Landmark Commission

**June 6th, 2019
1ST FLOOR CONFERENCE ROOM
4:30 P.M.
AGENDA**

APPLICATION FOR COMPREHENSIVE EXTERIOR RENOVATIONS TO 125 & 131 E WATER STREET

BIEMILLER - WEEDON BUILDINGS
ELEVATOR, STAIR AND STRUCTURAL PACKAGE
125 - 131 EAST WATER STREET
SANDUSKY, OH 44870

9' wide x 3' rise x 1' projection, open ended, shed style awning.

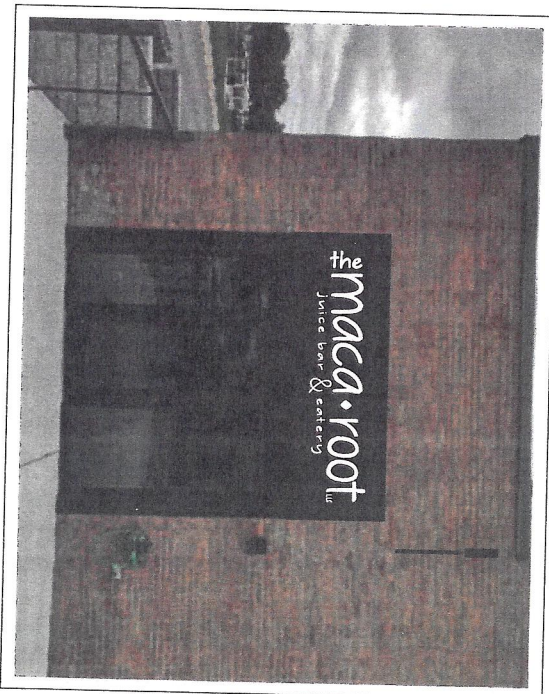
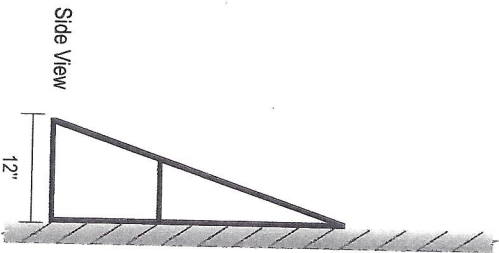
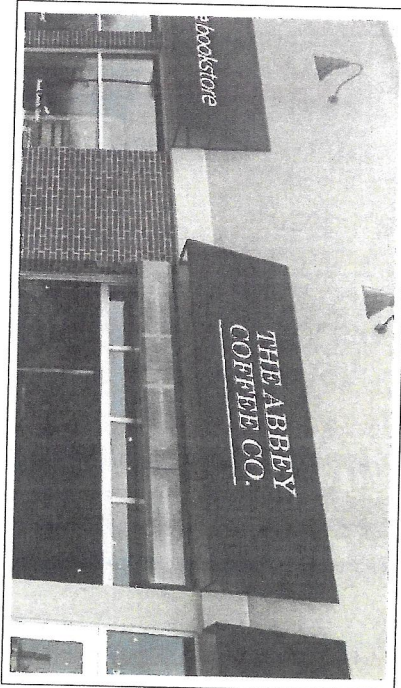
The awning will be black with white lettering and will be 27 square feet. It is described as an open ended, shed style awning and the bottom portion will project out one foot.

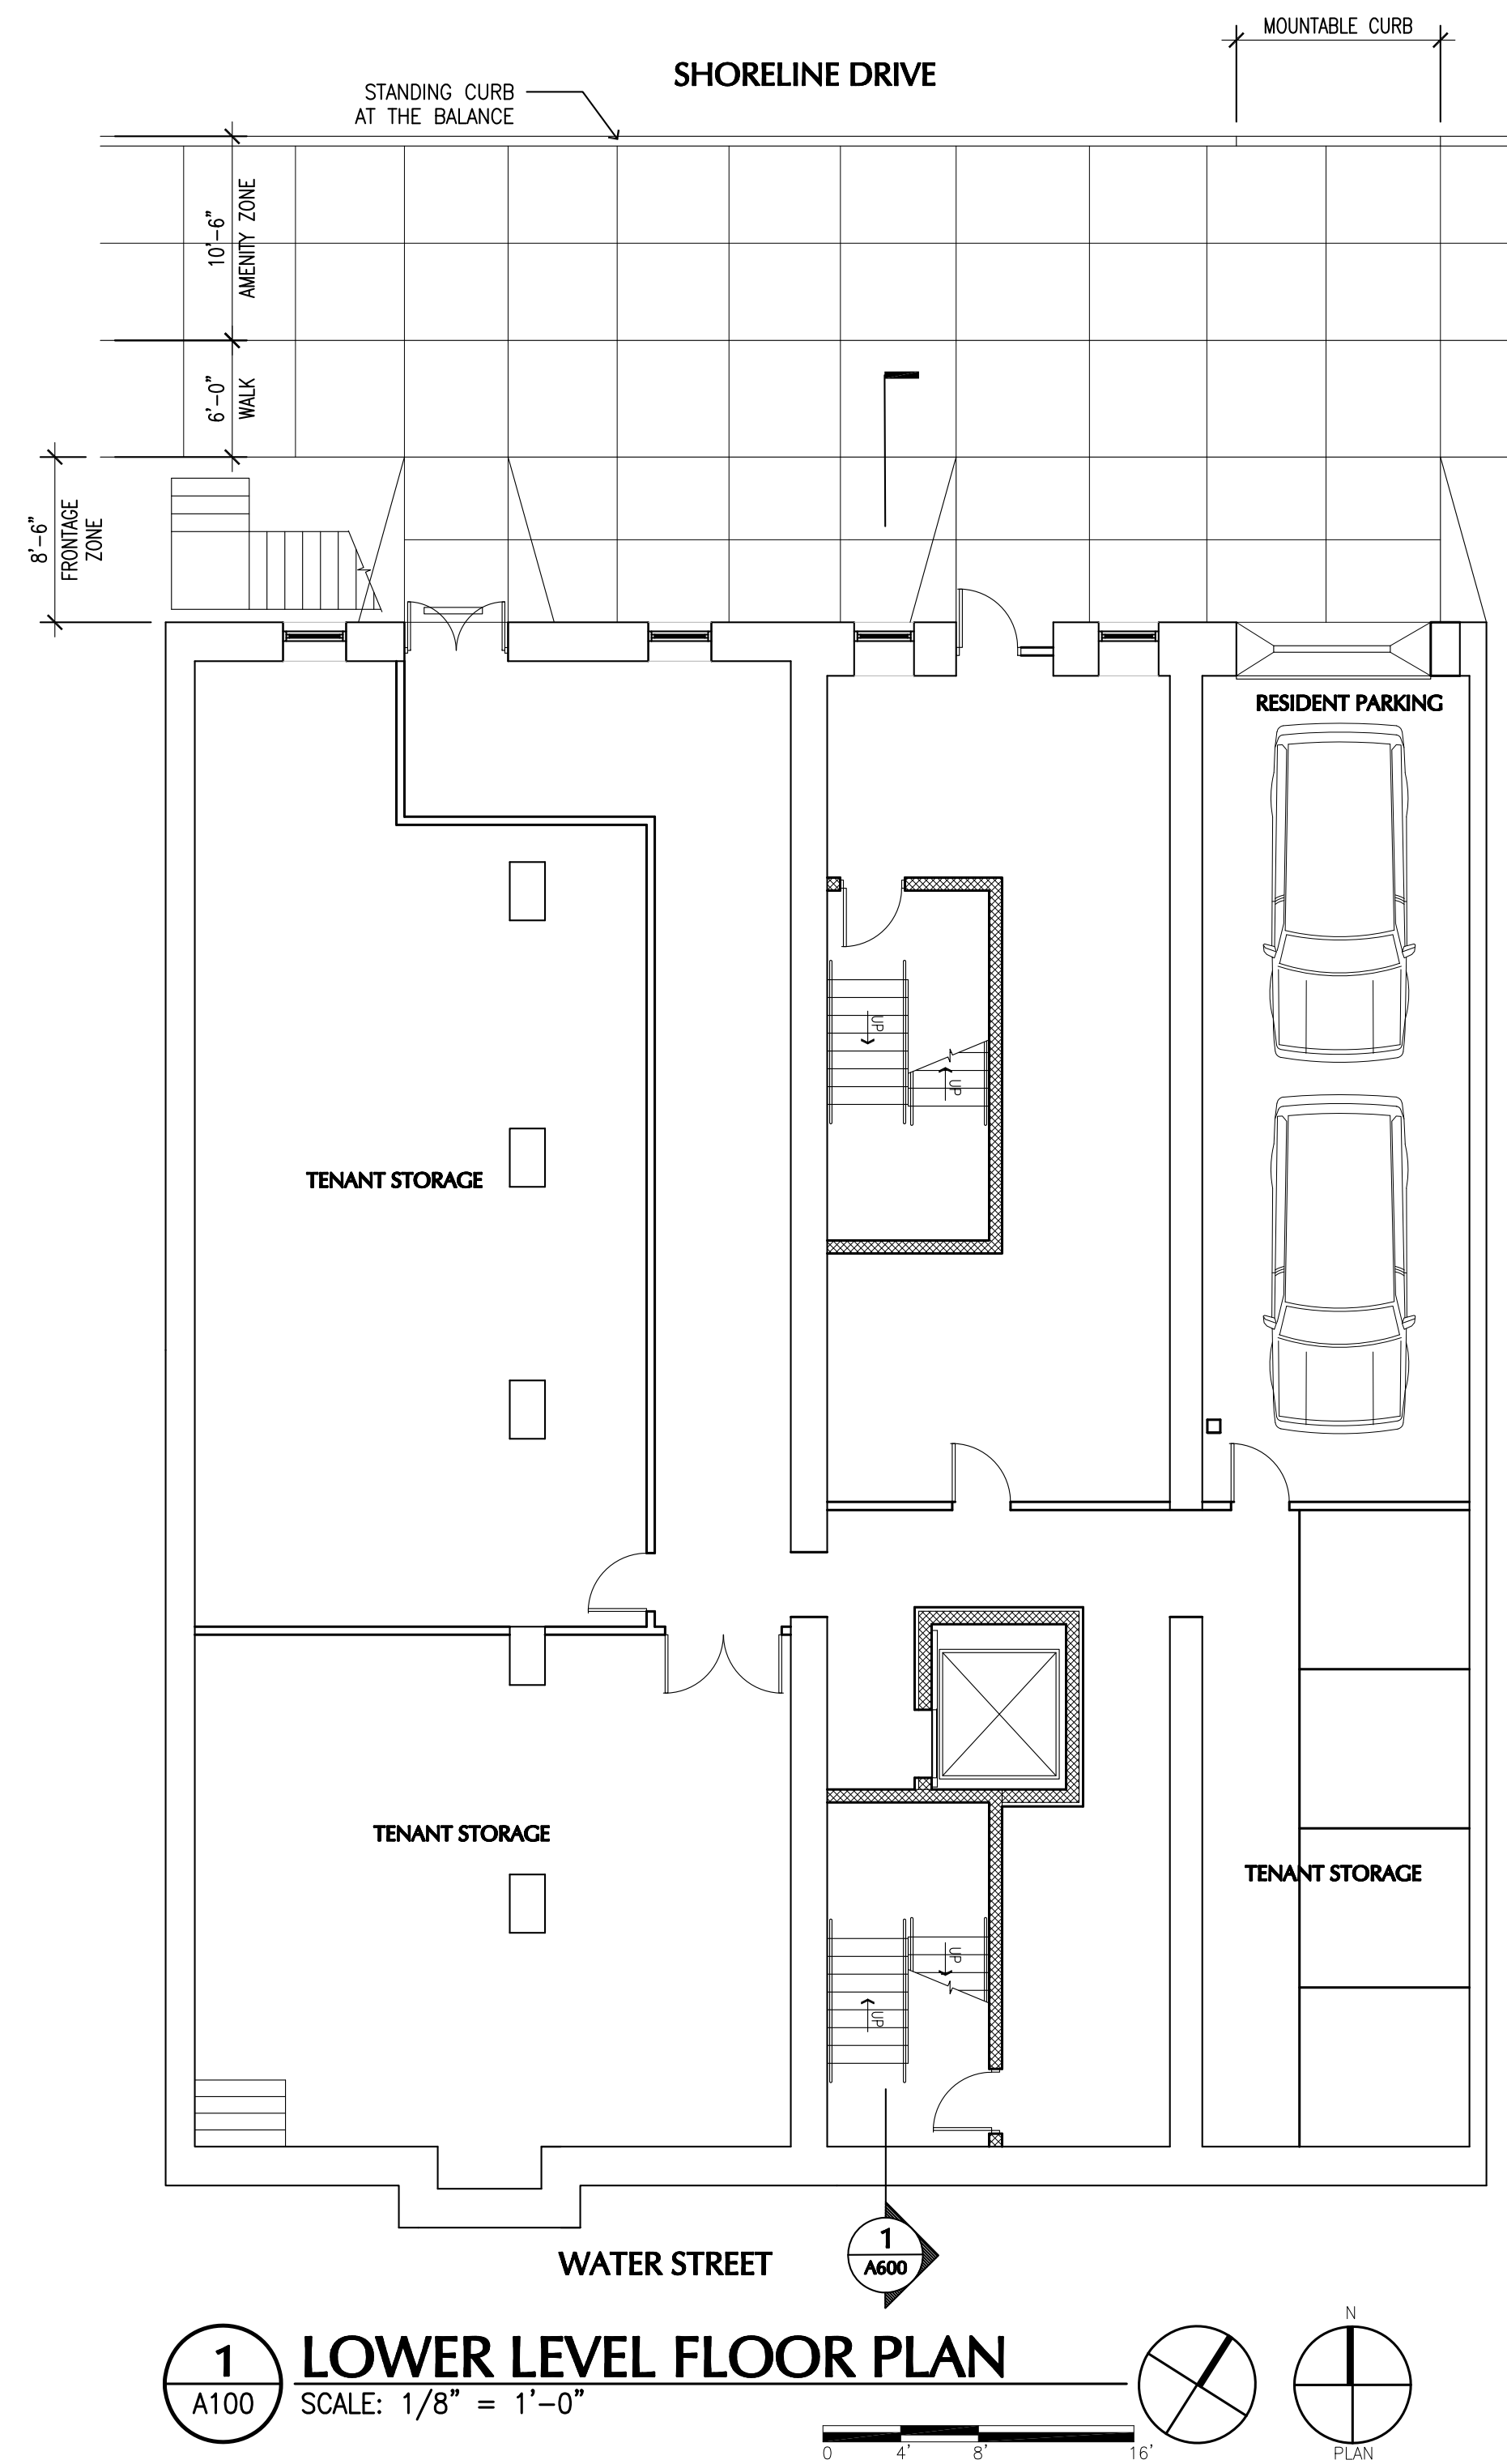
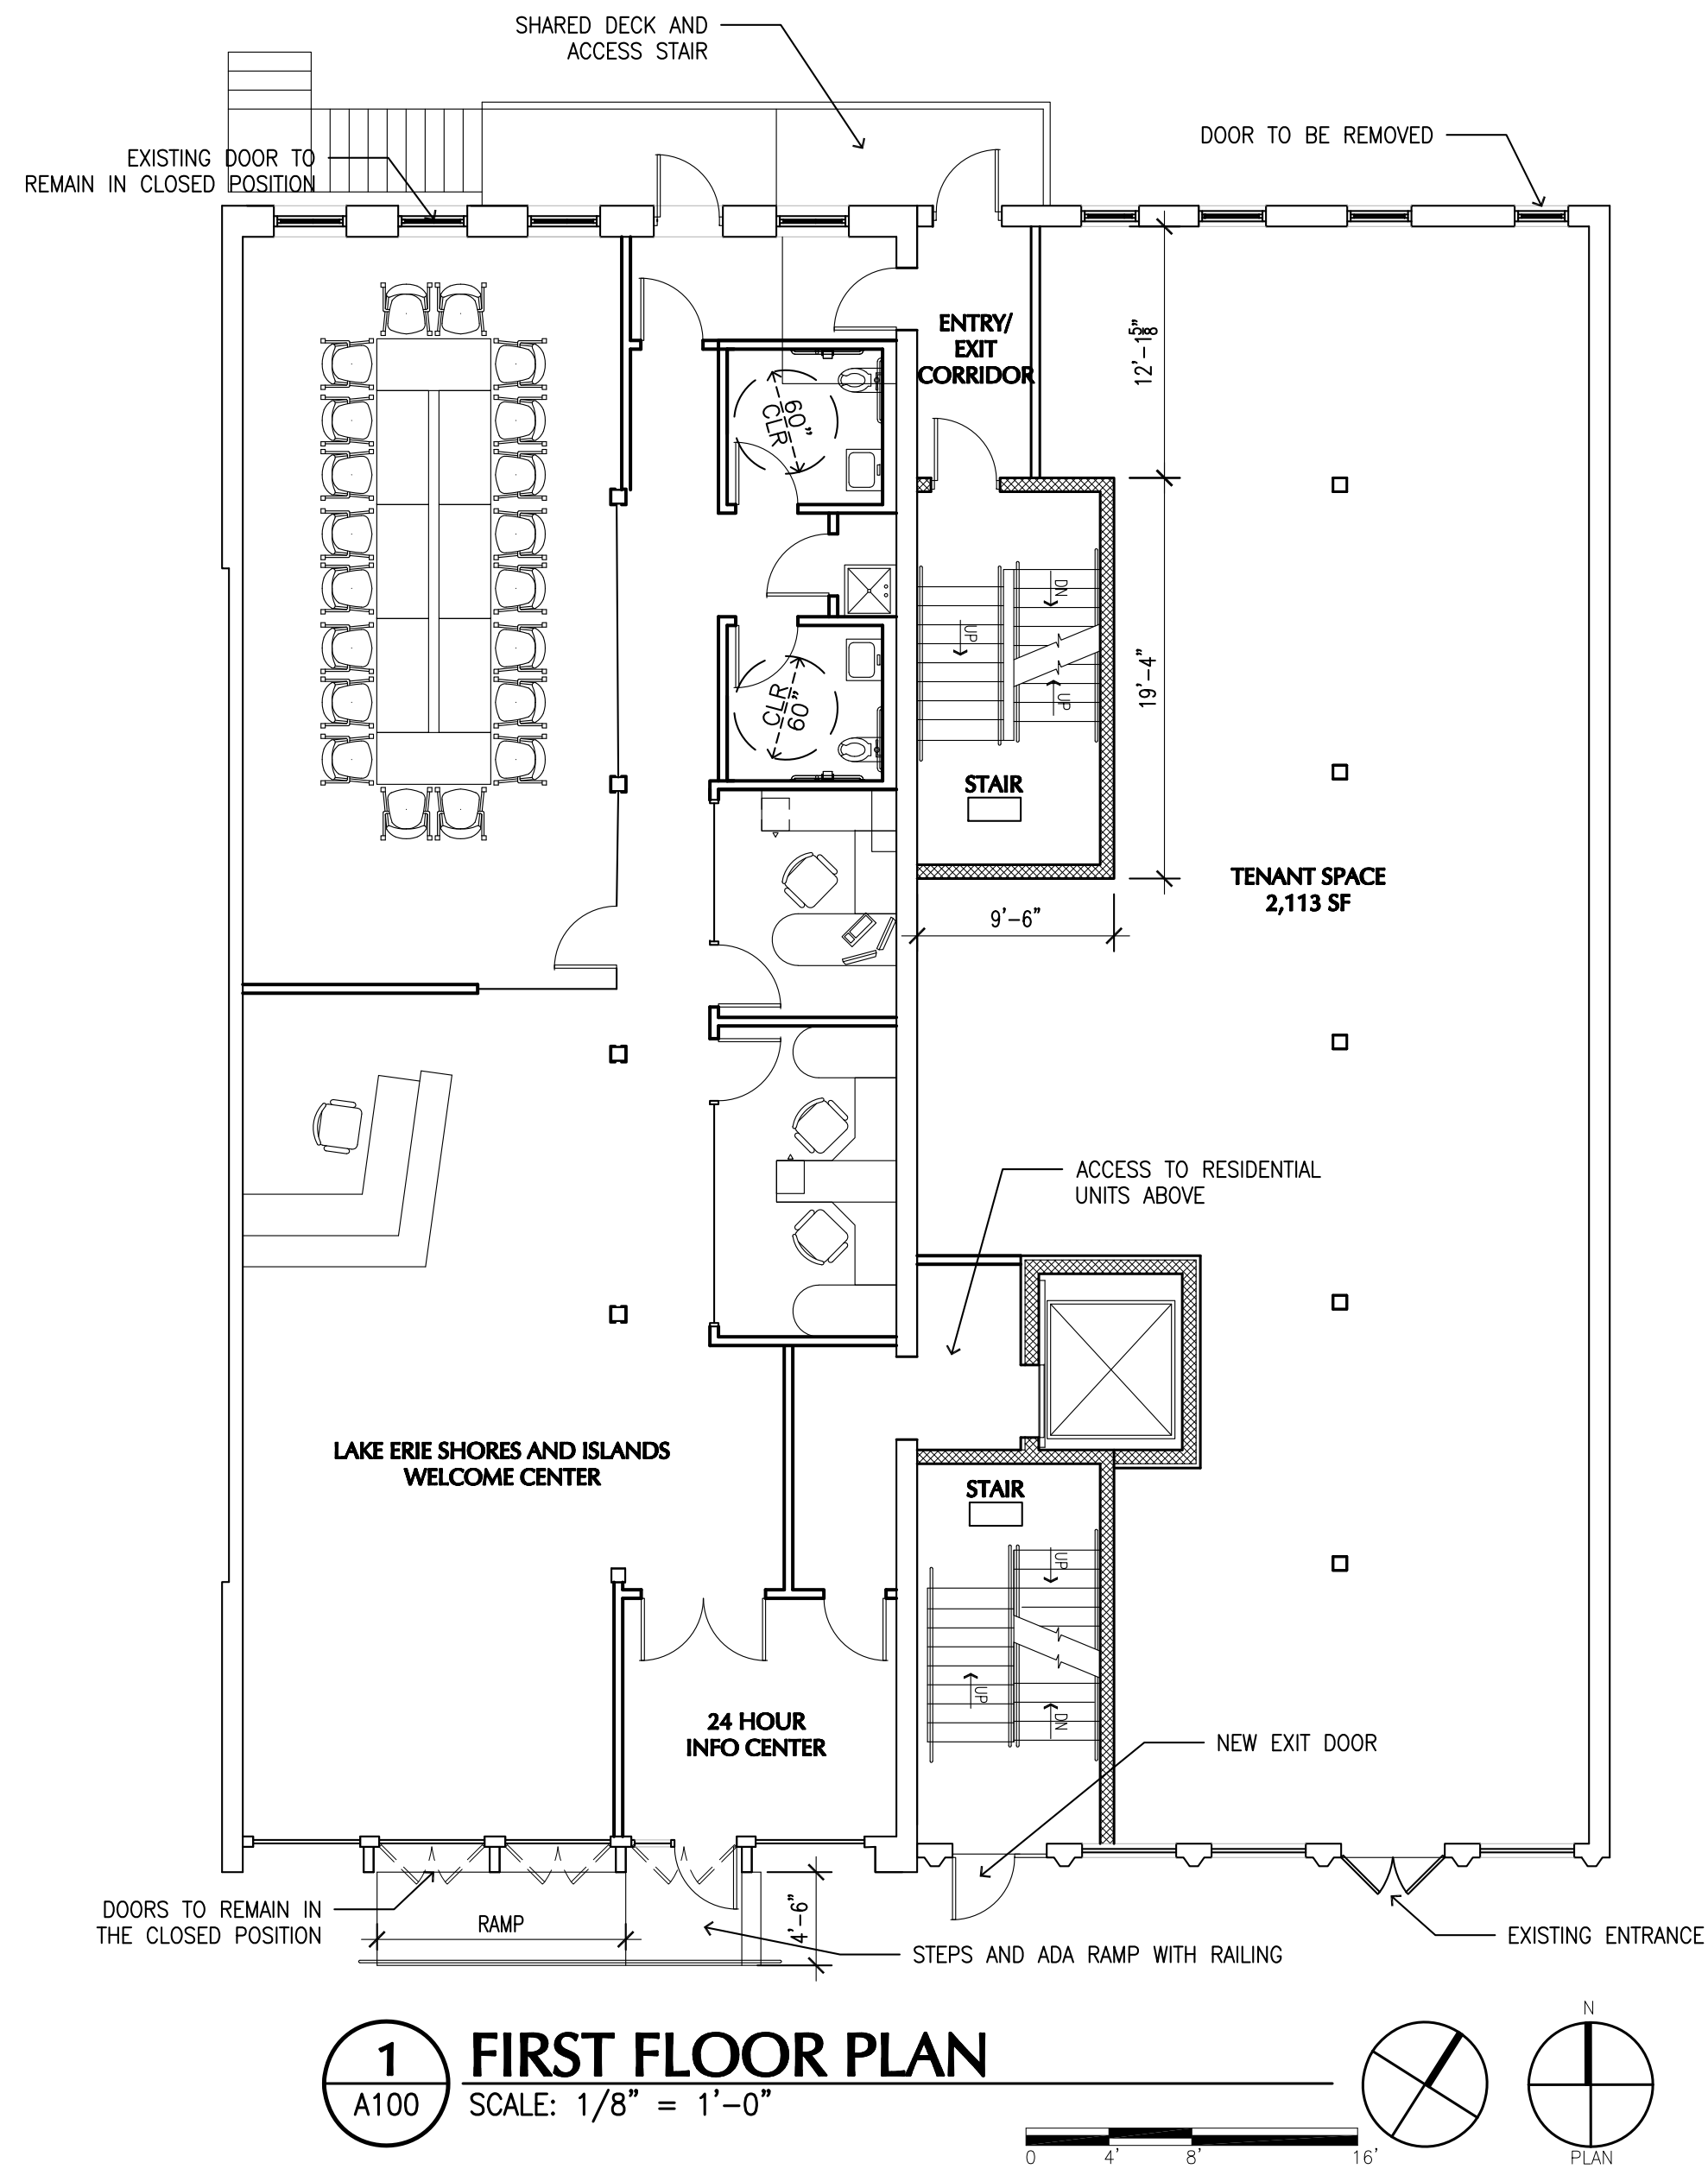
- The new door on 131 – Is there a reason that the door does not match the existing double doorway?
- Clarification on the materials of the windows on the north wall of 125.
- The material and color of the railing in the front entrance of 125

- The colors for the railings and doors on the exterior of the penthouse level
- The dimensions of the setbacks for the penthouse and rooftop deck.
- Concerns about the four curb cuts on Shoreline Drive. The Design Guidelines state that curb cuts should be minimized. This is especially true for Shoreline Drive, which is currently being reconstructed to be more pedestrian friendly. Staff asked the applicant to work with his engineer to reduce the curb cuts and proposed a mountable curb sidewalk to maintain comfortable pedestrian flow

Staff enthusiastically supports the rehabilitation of historic buildings in Sandusky, especially two of our oldest buildings on one of the city's main commercial streets. Staff recommends approval of the Certificate of Appropriateness application with the following conditions:

- 1) Per guideline to reduce curb cuts in the Sandusky Preservation Design Guidelines, & with the recent investment in the reconstruction of Shoreline Drive, staff recommends that the curb cuts be eliminated and that the garage access points be reduced from four down to one.—with a maximum width of 10 feet. The north exterior stairwell must be oriented sideways so that its protrusion into the right-of-way is minimized.

- 2) The access to the garage not be via a curb cut, but a drive via a mountable curb over the sidewalk that should minimize the obstruction of the sidewalk. It should match the design and color of the new Shoreline Drive streetscape. A cross section shall be submitted to the Planning and Engineering Departments for approval.

- 3) The color of the penthouse addition on the 131 E. Water Building should more closely match colors on the respective facades.
- 4) The addition of a new door to the front of 131 E. Water should be a double door to match the existing door.
